**MINUTES OF DISCUSSIONS
ON THE PREPARATORY SURVEY
ON THE PROJECT FOR REHABILITATION OF TRUNK ROAD, PHASE IV
IN THE FEDERAL DEMOCRATIC REPUBLIC OF ETHIOPIA
(Explanation on Draft Final Report)**

The Preparatory Survey on the Project for Rehabilitation of Trunk Road, Phase IV in the Federal Democratic Republic of Ethiopia

Fig.-3 Issues of Connecting Point to existing A3

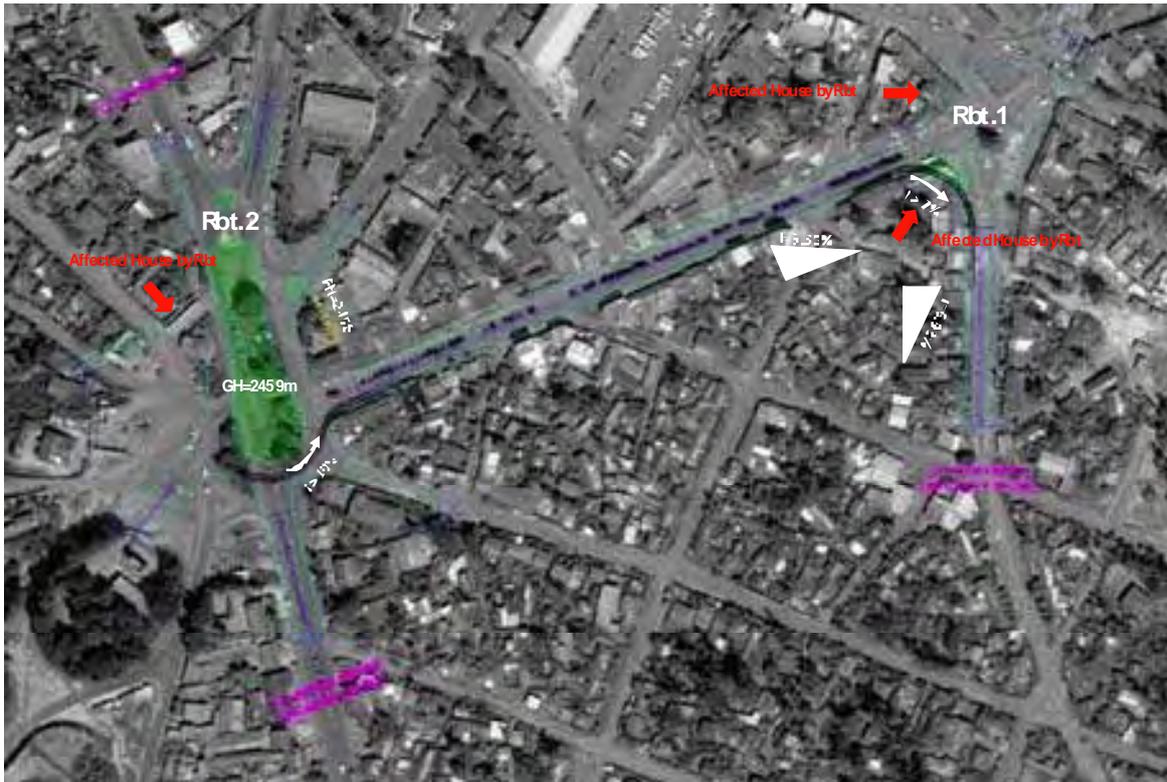
As mentioned earlier, the DD route by HEC passes two new roundabouts located within a congested town area before connecting to the existing A3. However, the elevation difference of A3 and DD route at connecting point at Rbt.2 is approximately 3m. This will result in a steep grade of more than 10% at Rbt.2 and more than 7% at Rbt.1. Consequently, these poor geometric features will constrain heavy trucks that commonly use this route. In addition, unexpected affected houses will likely be increased with the construction of roundabouts.

- ① The rehabilitation plan of existing A3 (Alt.2) is superior to DD Route by HEC (Alt.1) in all items of technical aspect.
- ② Transit traffic and local traffic should be separated as much as possible, so it is common practice that the international trunk road should be planned to avoid to passing through the center of populous city.

Figure-3 Countermeasure Concepts Proposed by the Study Team

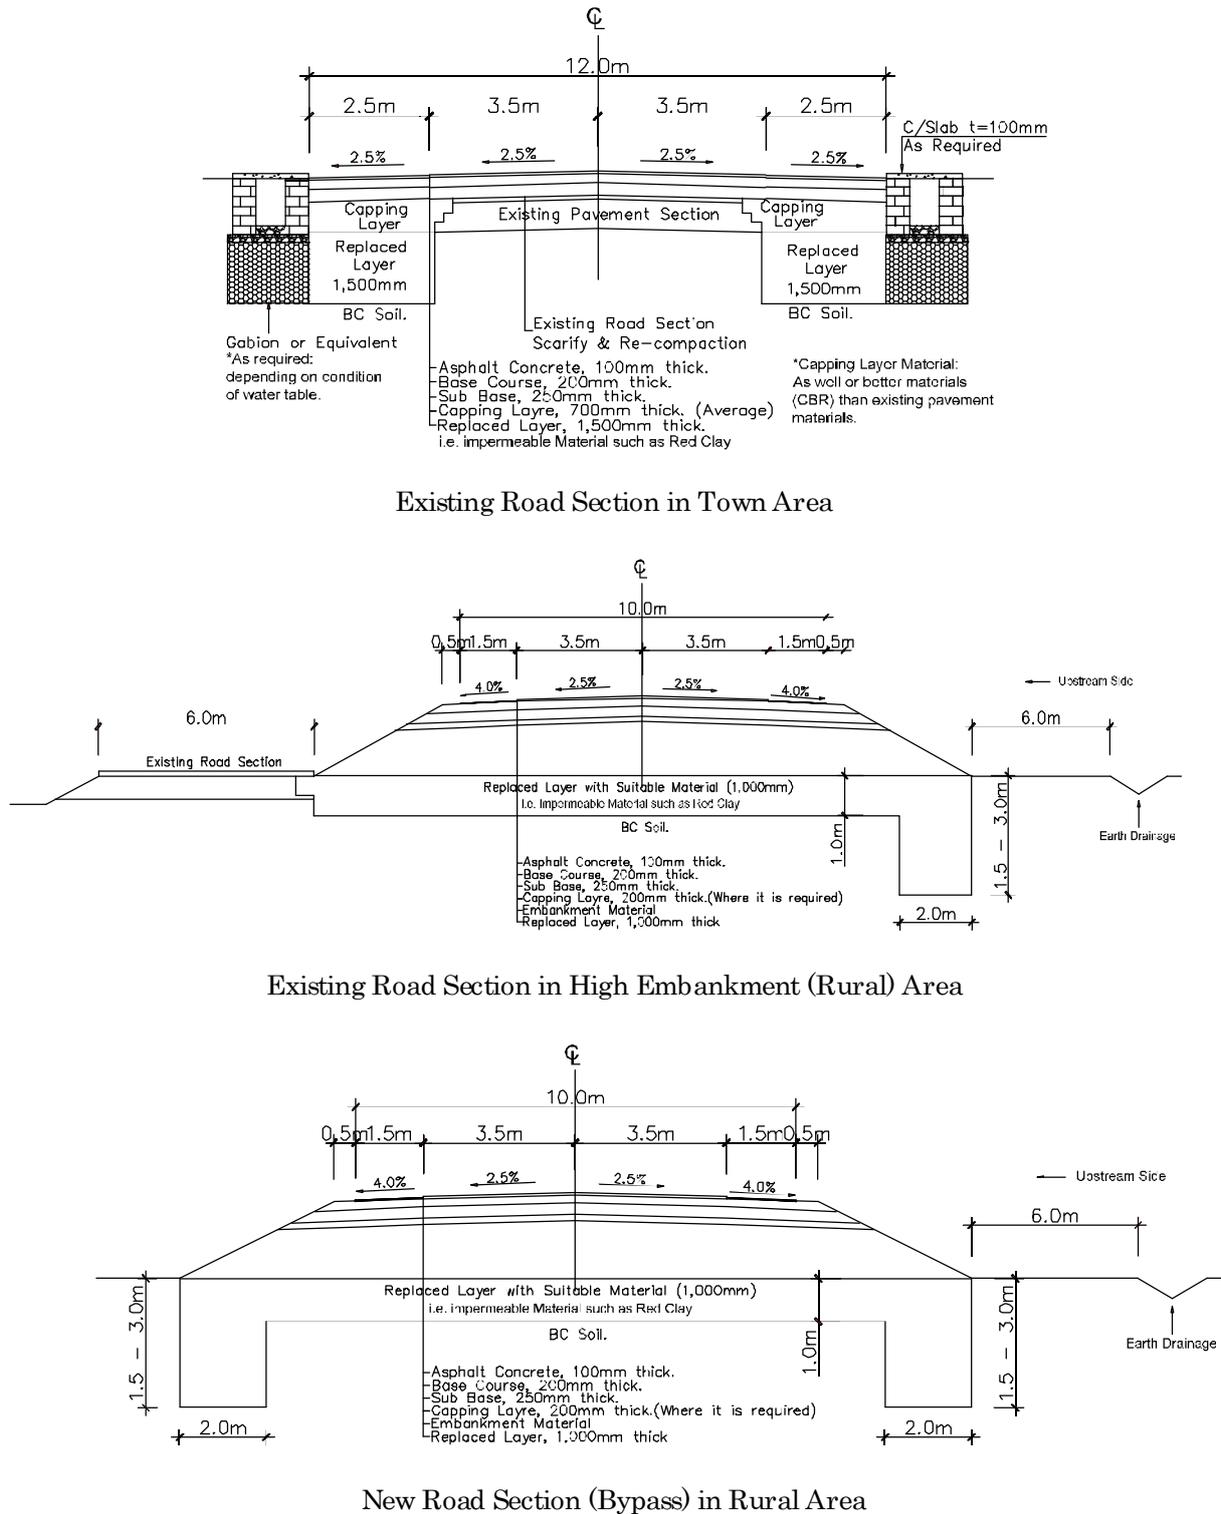
Regarding countermeasure for expansive (black cotton) soils, our proposal was agreed by your side but only in principle with some comments. Your comments were that the Consultant should incorporate a filter membrane (such as geo-textile sheet) and an impermeable membrane on the outer and inner face of the buried gabion, respectively. The inclusion of such membranes and protection method for gabion bed will be decided at a later stage after confirming matters such as highest ground water table, etc, and determining whether or not buried gabions will be applied. At the moment, the concept is to have the image of the probable features of road cross section in town areas. Moreover, your side recommended that a provision for side drains be indicated on the typical cross sections on the existing road section in high embankment and new road section in rural areas.

In response to your comments, we have duly modified our proposal for typical cross sections to be adopted in cases where black cotton soils are predominant. Please see the attached document titled "Countermeasure for expansive soil on the Trunk Road A3 between Dejen and Debre Markos"

Alternative-3 (Figure-3) has replacement thickness 1.0m under road embankment and vertical barriers on both sides which function to prevent the change of moisture content and confine it instead of horizontal blanket employed in Alternative-1 and -2. Vertical barrier depth of 3.0m is planned by considering fluctuation area of water content (refer to Figure-1). This vertical barrier depth of 3.0m is planned to be adopted for Abeya and Yeda river area. Depth of vertical barrier will be varied depending on BCS thickness in other locations.

Figure-1 Comparative Illustration at Chemoga

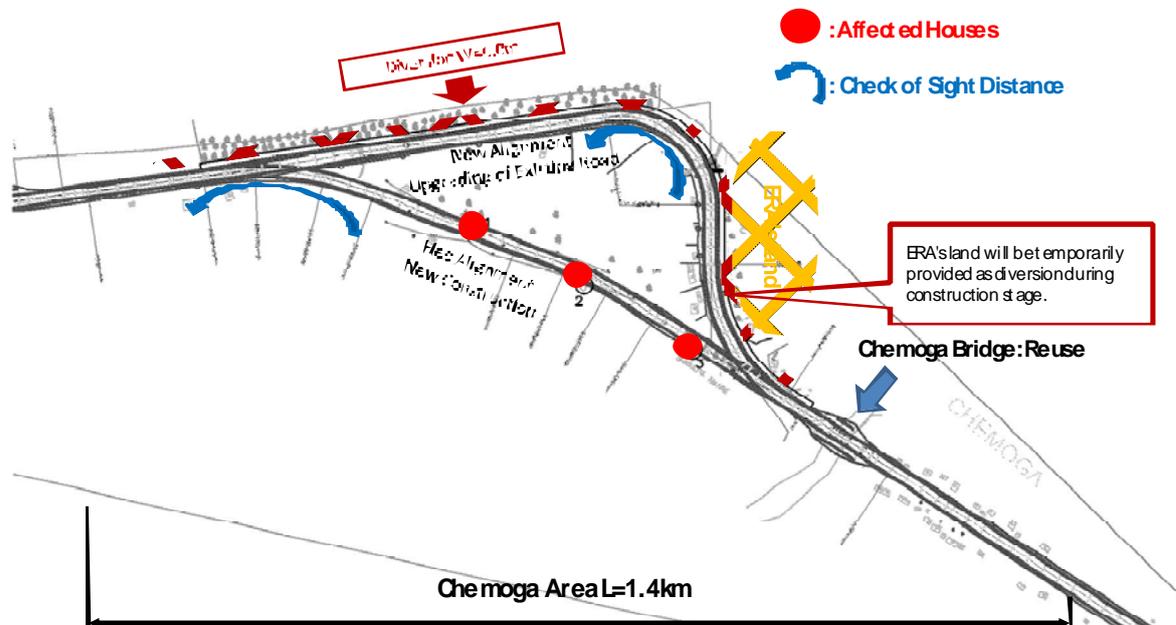
Our explanation aims at resolving the issues of Road Alignment at Chemoga (Sta. 58+000 ~ 58+700) and Applicable cross sections in Debre Markos Town (Sta. 60+800 ~ 65+400), including road width and median width.

This is in reference to your letter Ref. No.. ERA/ADM/101126/PO dated November 26, 2010 through which you have forwarded your recommendation on the proposed road alignment at Chemoga and cross sections within Debre Markos town for our comment and subsequent endorsement.

- In most cases, there is a problem of proper design of junctions and vehicular crossings at town sections. Hence, please be advised to include detail junctions and vehicular crossings in the town sections.

HEC Alignment	New Alignment
Geometric	Min. Radius	270m	100m
	Max. Grade	8.0%	5.8%
	Applicable design speed	50km/h	50km/h
	Regulatory Speed	30 – 50km	
	Calculated Sight Distance	111m > 55m	68m > 55m
Applicable Cross Section			
No. of affected houses		3	0
Land required	Road reserve	New land is required because of new road construction	Width of upgraded road will be within existing road reserve area.
	Diversion during construction stage	It is not required because of new construction road.	Diversion with 6m will be provided by use of a part of ERA's land.

Accordingly, we have reviewed the revised proposal and found it acceptable. Hence, we have no objection for the proposed road alignment at Chemoga and typical cross sections within Debre Markos town.
